STANDARD FIELD SERVICE BULLETIN

FSB Number	CHRAEFSB2014-89
Author	Anthony Bryan
Date	08/11/2014
Subject	Camera Flash LED
Model Affected	Moto G (XT937C, XT939G, XT1028, XT1031, XT1032, XT1033) and Moto G 4G (XT1039, XT1040, XT1042, XT1045)
Level Of Repairs	Level 2

Figure 1 - Example Photos

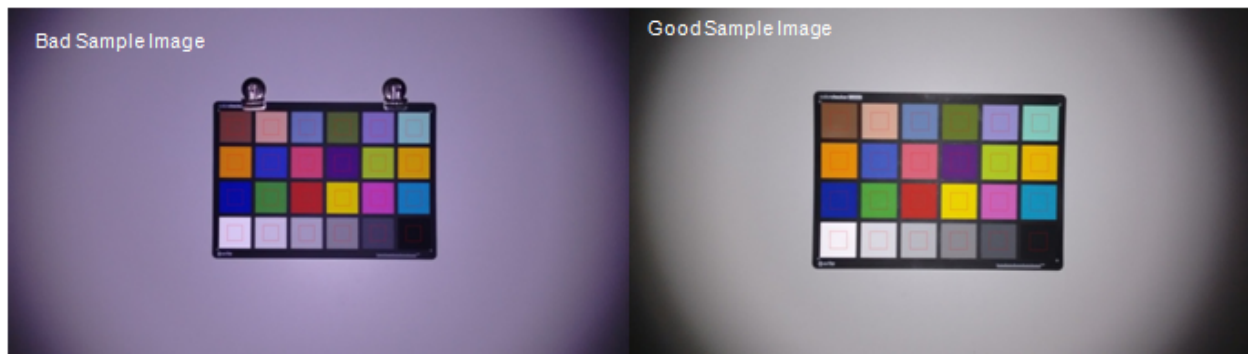
Motorola is aware of a potential field return issue on the Moto G and Moto G 4G products related Camera Flash performance. It was identified that some of the Flash LED's received by a particular supplier were not meeting Motorola standards for white balance. Affected devices may not achieve the same level of quality when capturing photos in low light conditions where the Flash LED is triggered. Photos captured in low light condition with the the affected Flash LED's may appear dark, washed out, or have a bluish tint. See the Example Photos shown below in Figure 1.

Figure 2 - Flash LED Suppliers

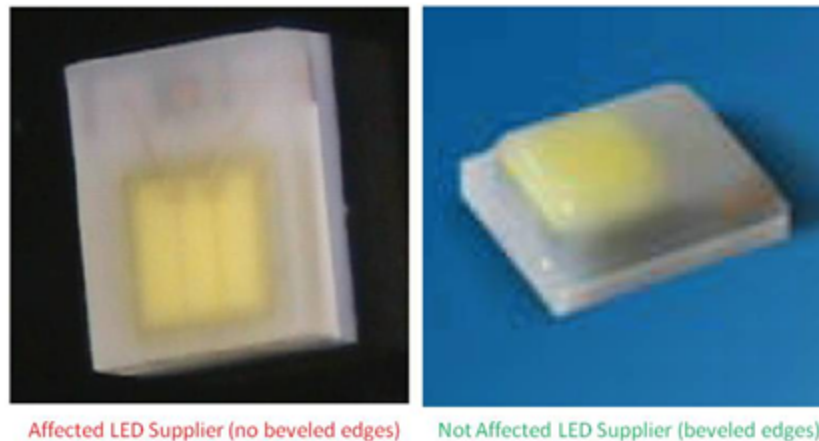
The affected Flash LED supplier (part image shown below) has implemented corrective actions into their process and are currently shipping only material that fully meets Motorola standards as of August 7th, 2014. Supplier will screen on-hand material built prior to August 7th, 2014 and apply a "Flash OK" marking to screened good material.

1. Regardless of whether or not complaint can be confirmed through functional testing, replace the Rear Housing Assembly (Service P/N: 010176880xx).
2. Following normal service procedures, completely reassemble and retest the device to ensure proper repair.
